Product Change Notification / MFOL-28NMYX712

CCB 5167 Initial Notice: Qualification of MMT as an additional assembly site for selected MCP2561 and MCP2562 device families available in 8L DFN (3x3x0.9mm) package.

CCB 5167
Pre and Post Change Summary
PCN# MFOL-28NMYX712

Lead Frame Comparison

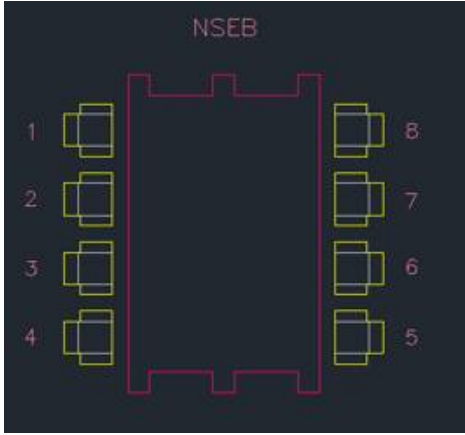
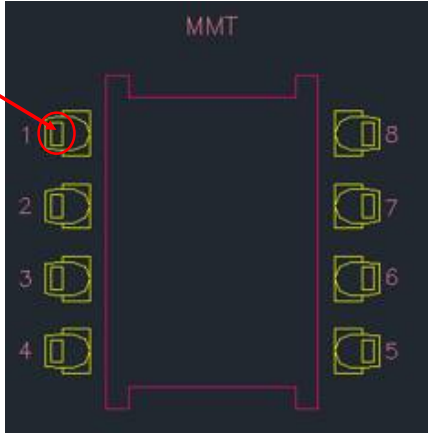
Lead-lock	No
-----------	----

Lead-lock	Yes
-----------	-----

Note: Mold compound material fills the lead-lock hole, which provides improved protection against moisture penetration along the edge of the leads (pins) of the package.
